**TITLE 675 FIRE PREVENTION AND BUILDING
SAFETY COMMISSION**

LSA Document #03-71(F)

DIGEST

Rule 4.2. Indiana Residential Code

FIGURE R502.8
CUTTING, NOTCHING AND DRILLING

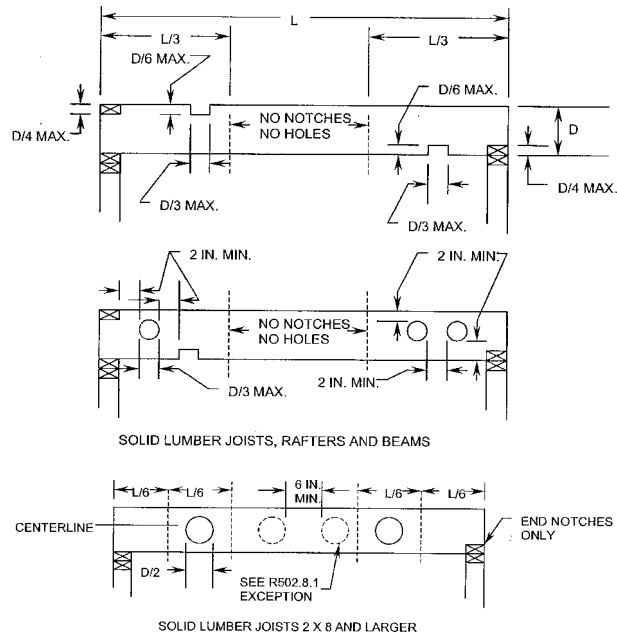
Sec. 69.6. Delete FIGURE R502.8 and insert FIGURE R502.8:
